HOMESTEAD NORTH AT STERLING RANCH FILING NO. 1

JOB NO. 25188.00
JUNE 22, 2022
SHEET 1 OF 6

Final Plat Drawings_v2 MTD.pdf Markup Summary 8-5-2022

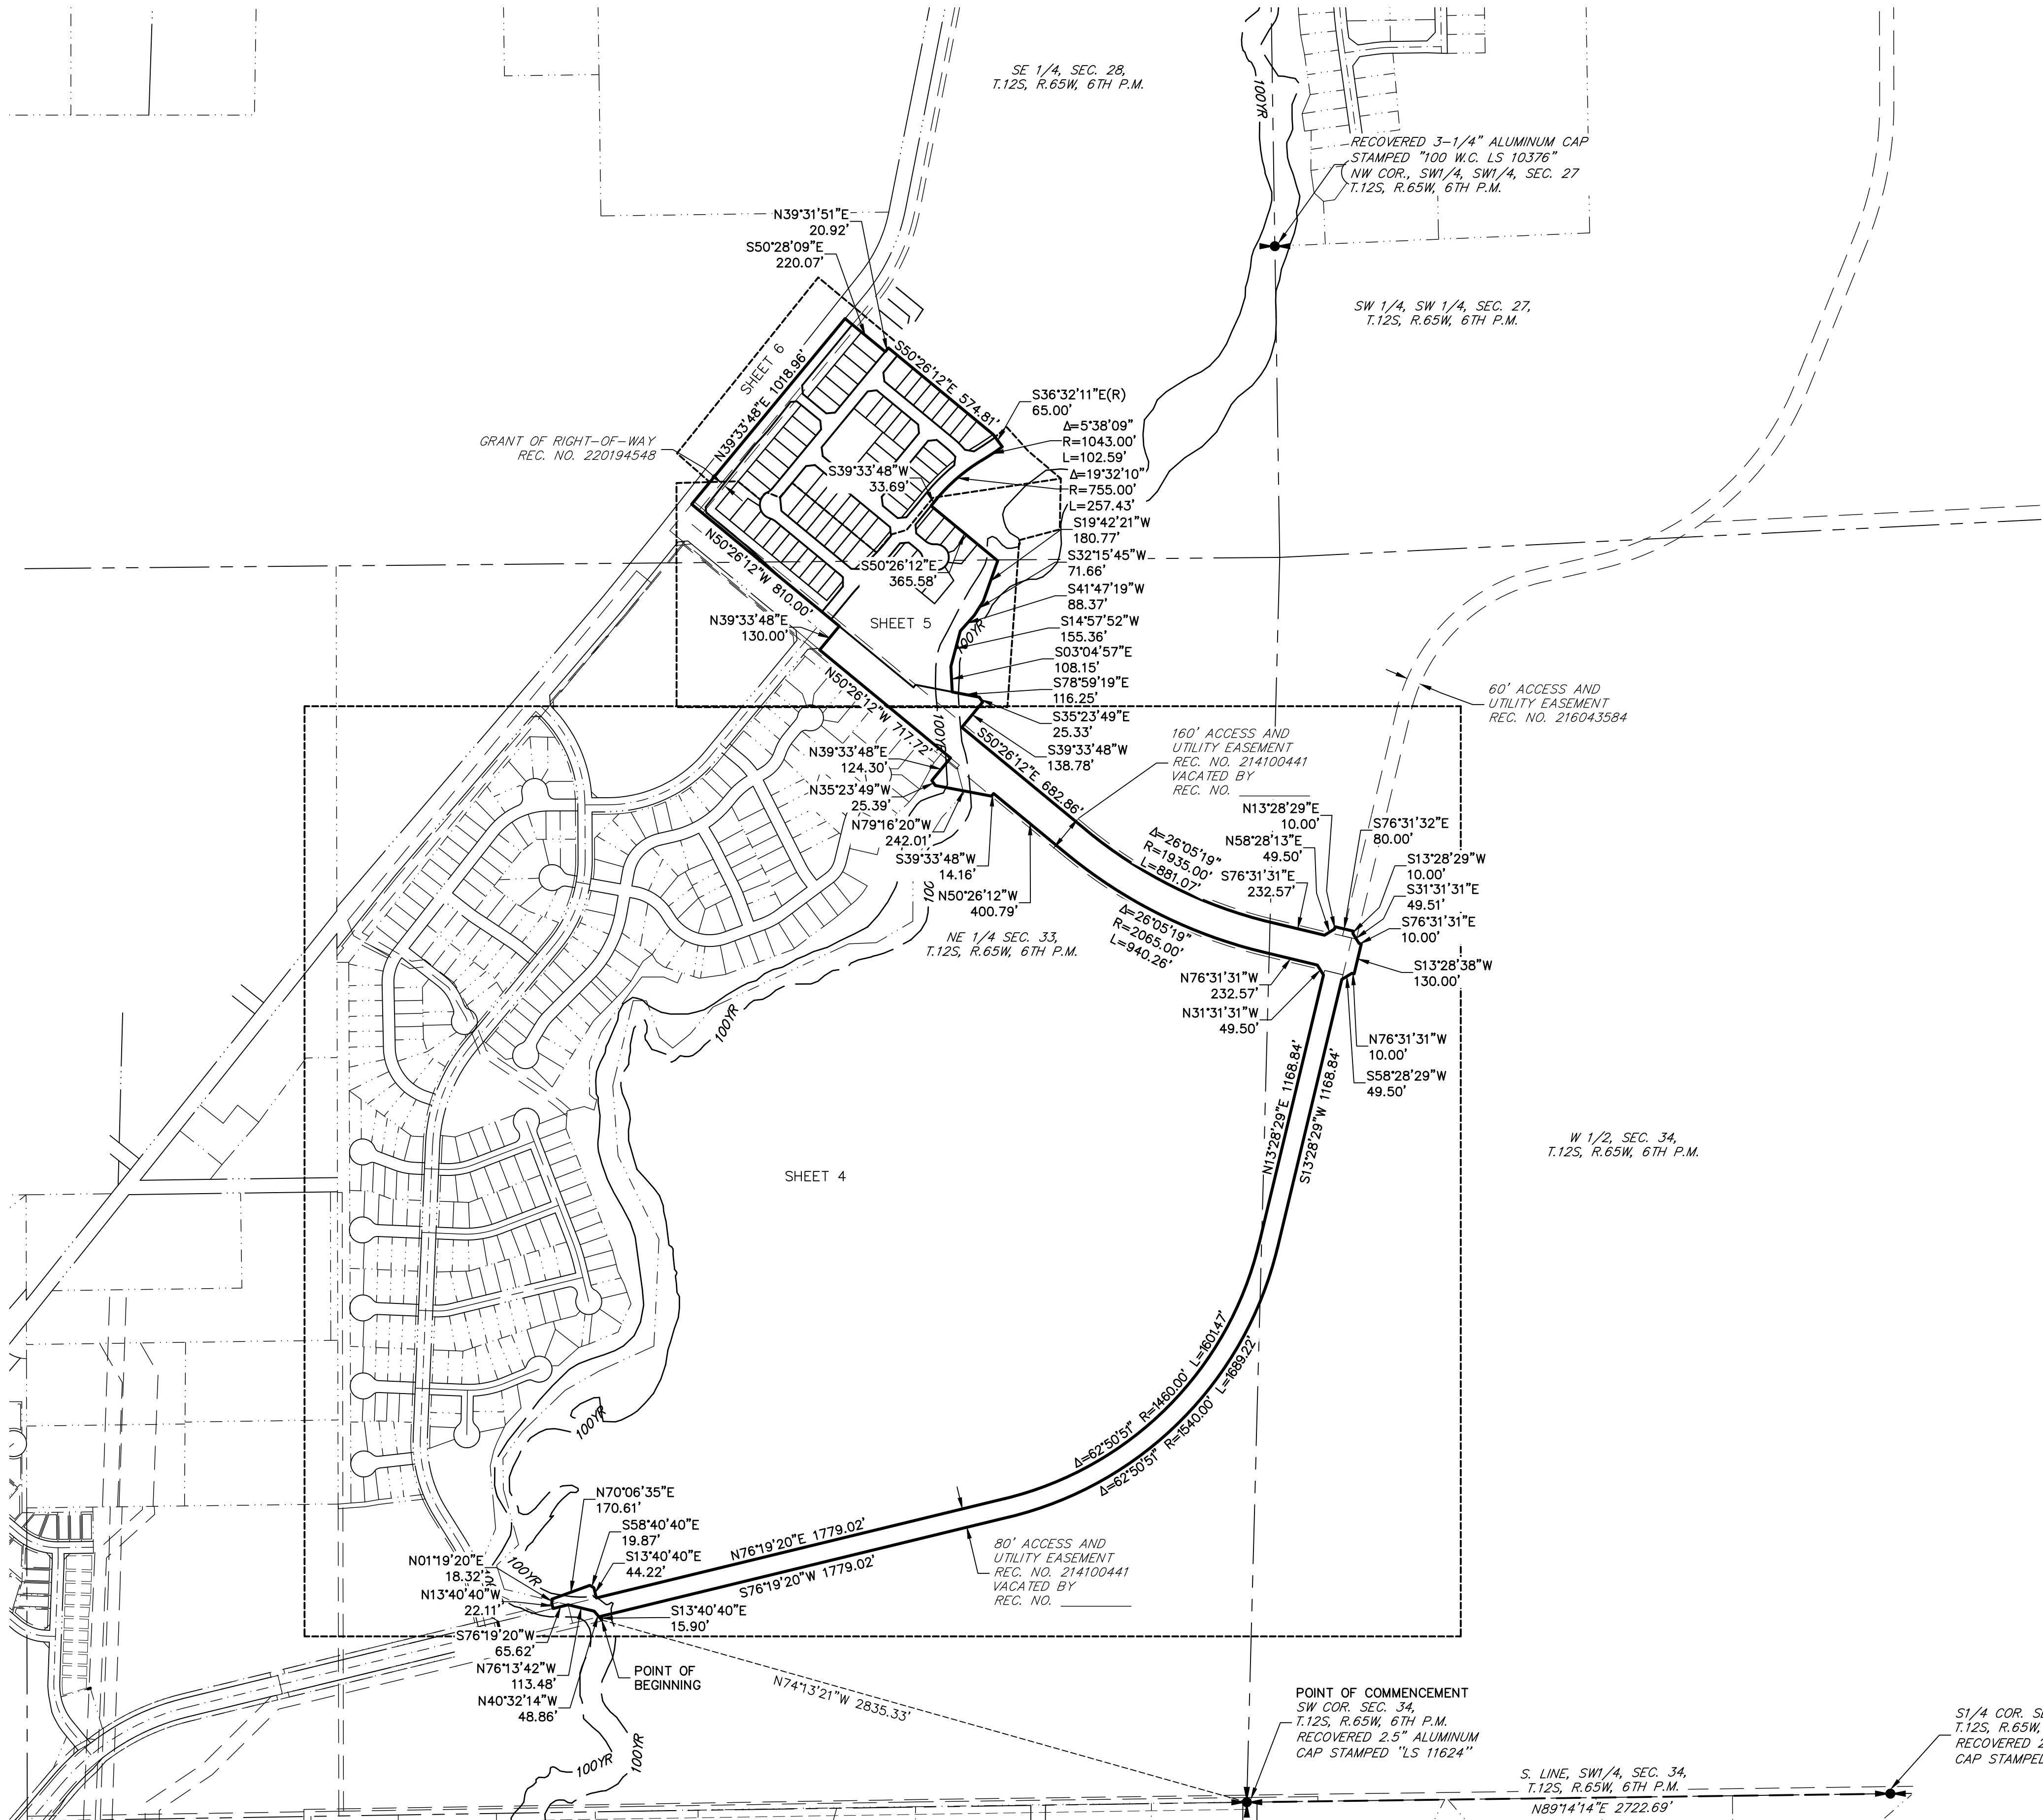
Per Loren HOA will be created for covenant control

scrub docs notes we are the Planning and Community Development Department

Fill in

JOB NO. 25188.00
JUNE 22, 2022
SHEET 4 OF 6

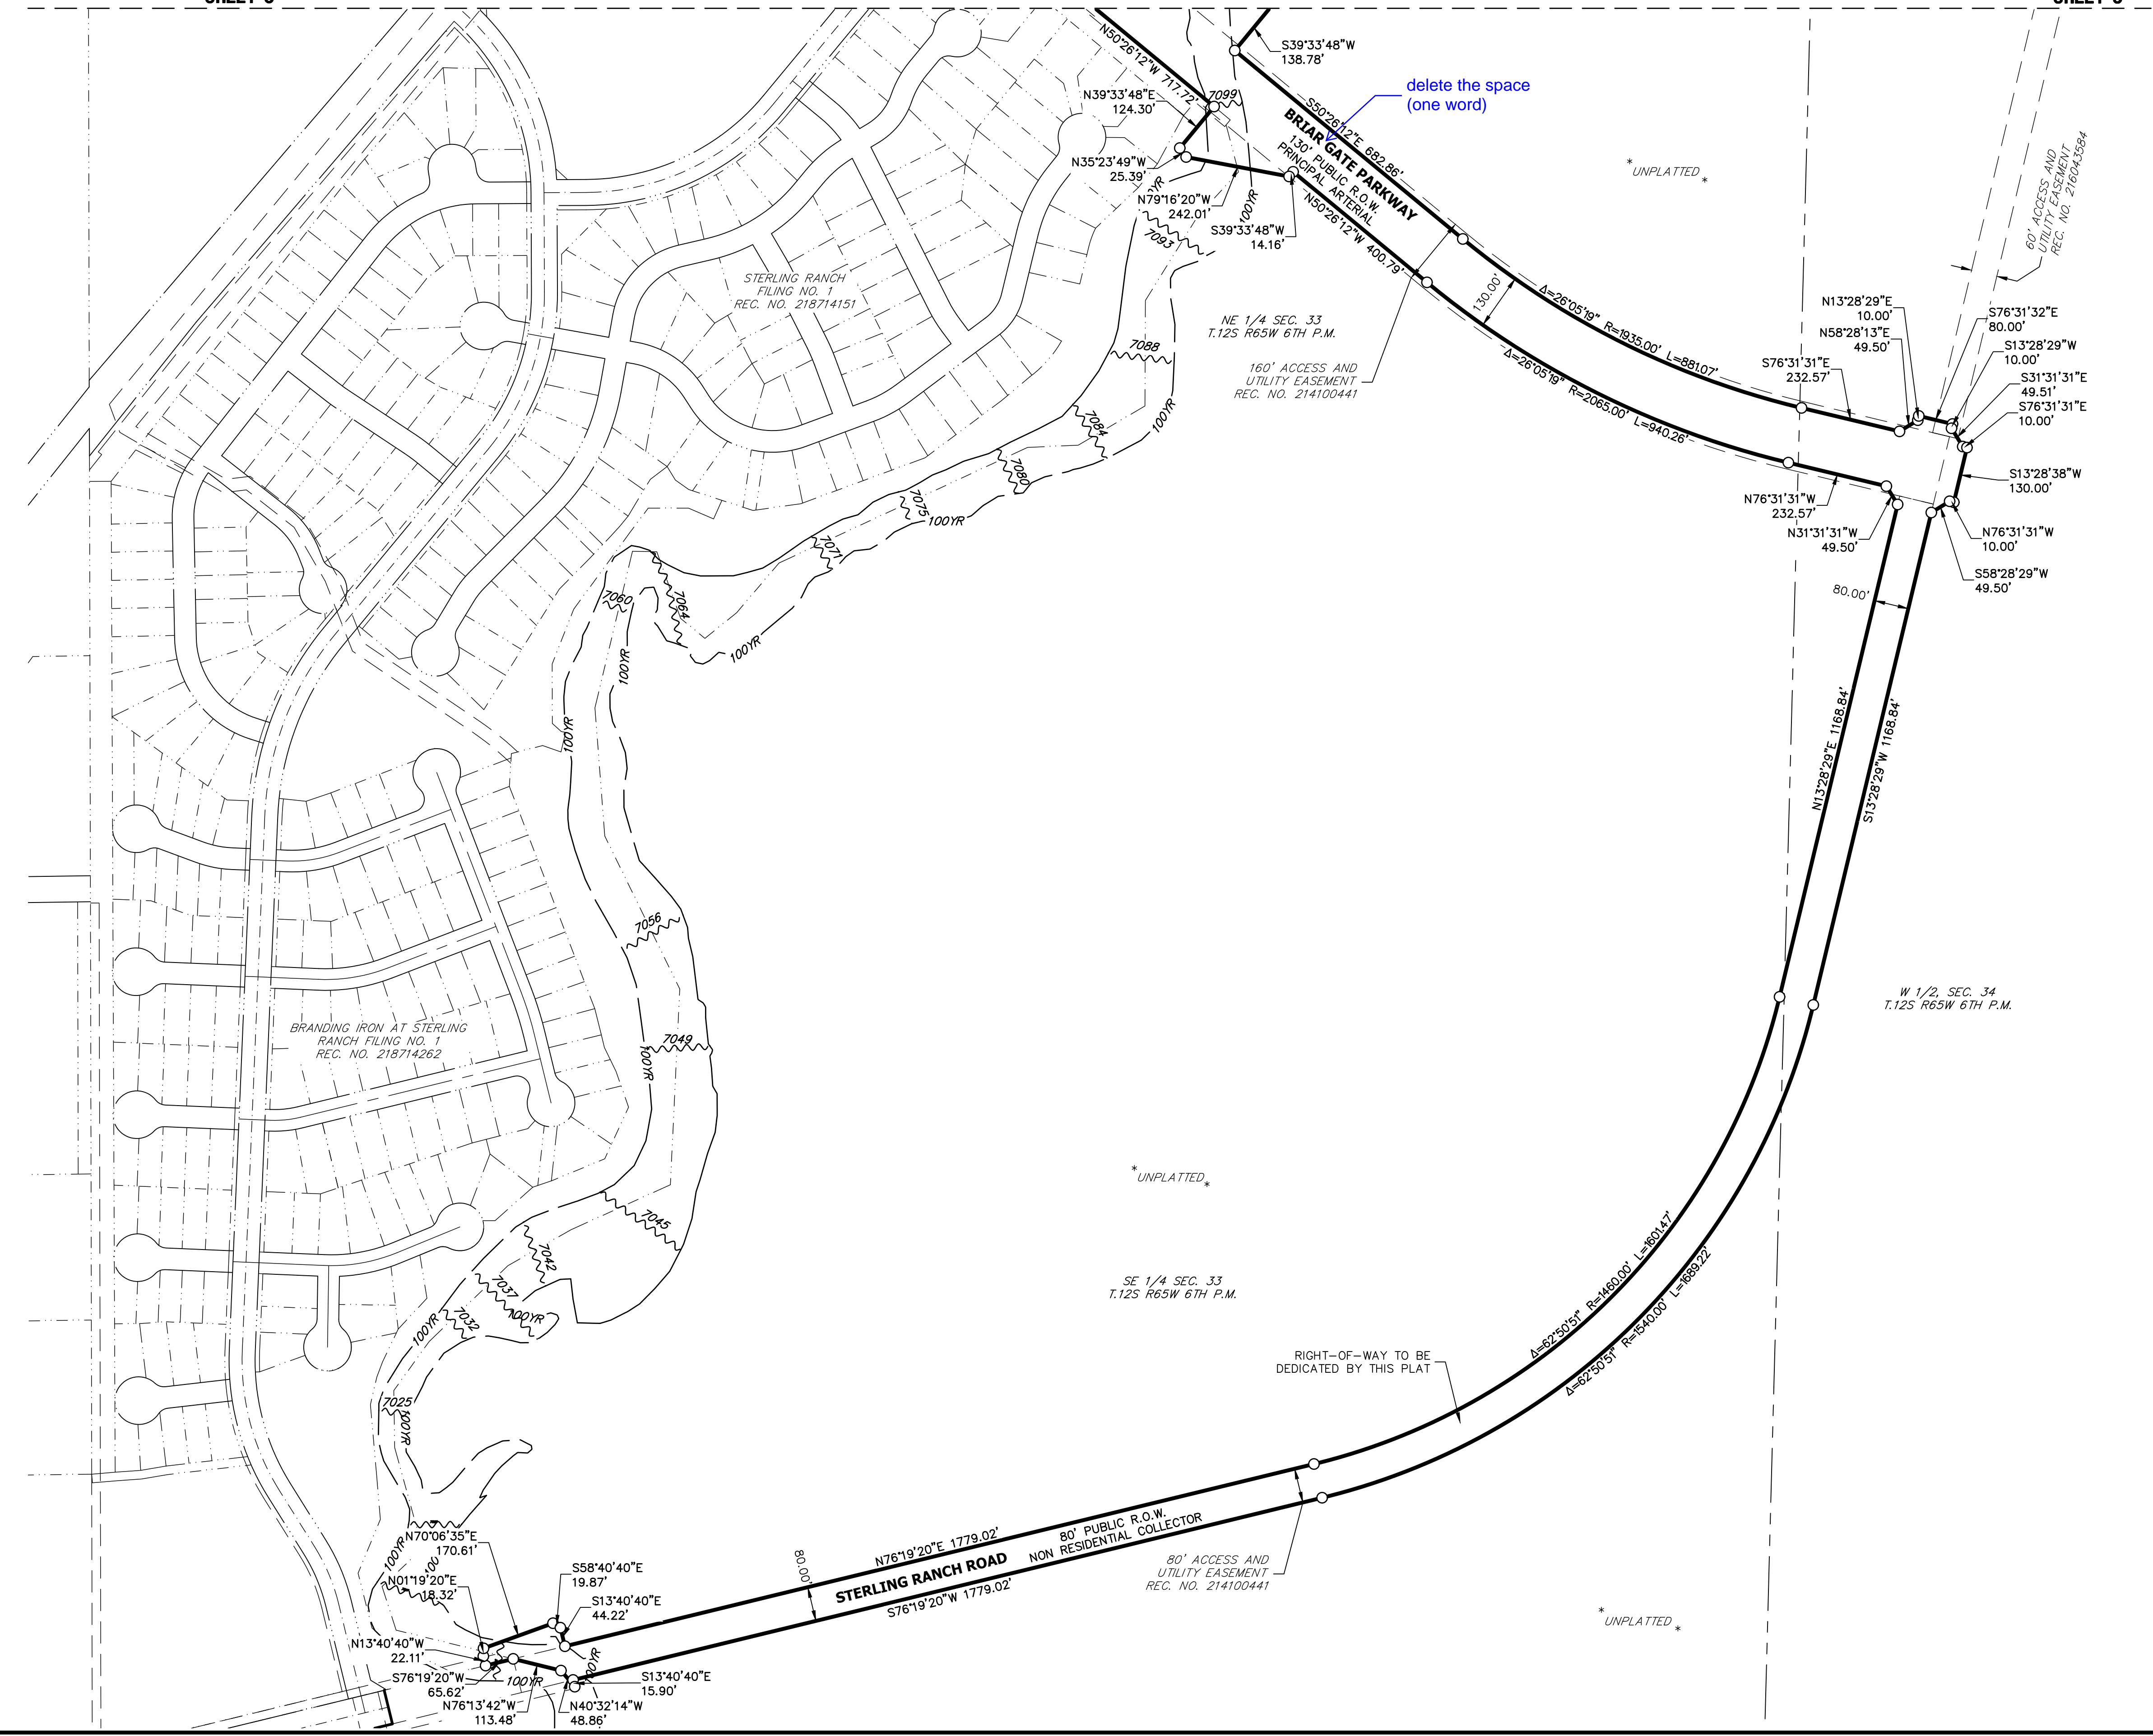
delete the space (one word)

JOB NO. 25188.00
JUNE 22, 2022
SHEET 5 OF 6

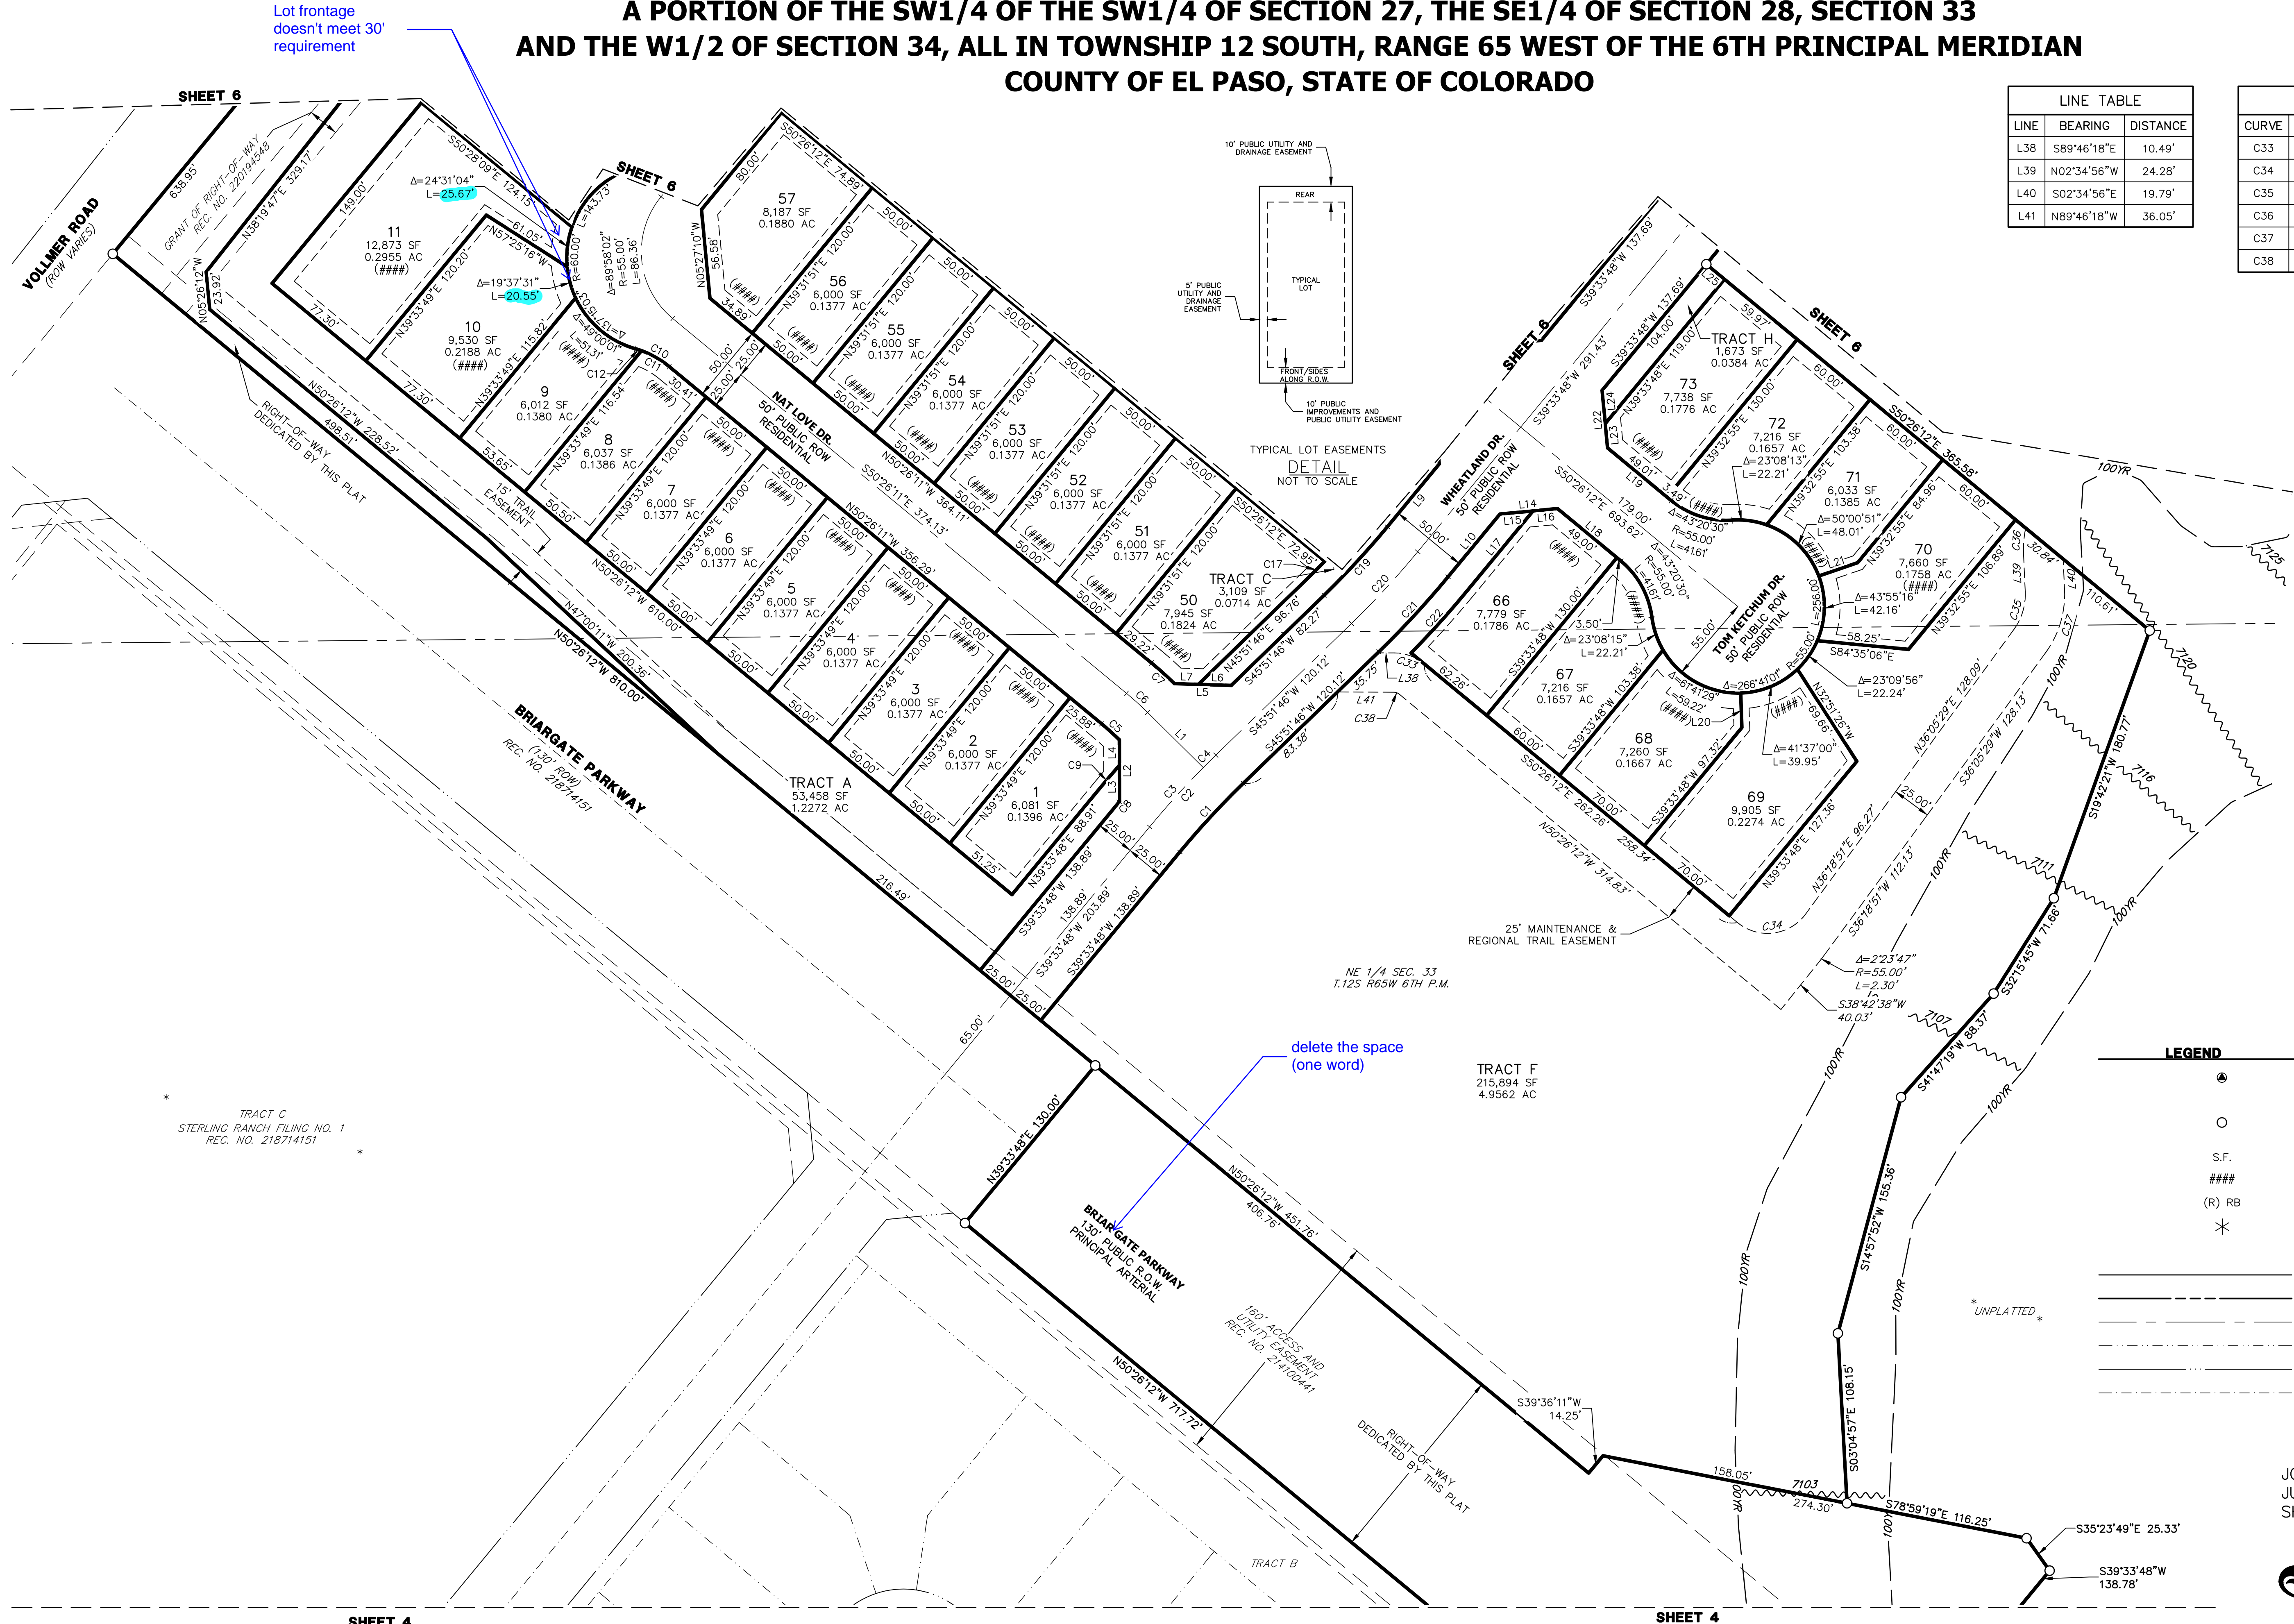
delete the space (one word)

Lot frontage doesn't meet 30' requirement

19°37'31"
L=20.55'

24°31'04"
L=25.67'
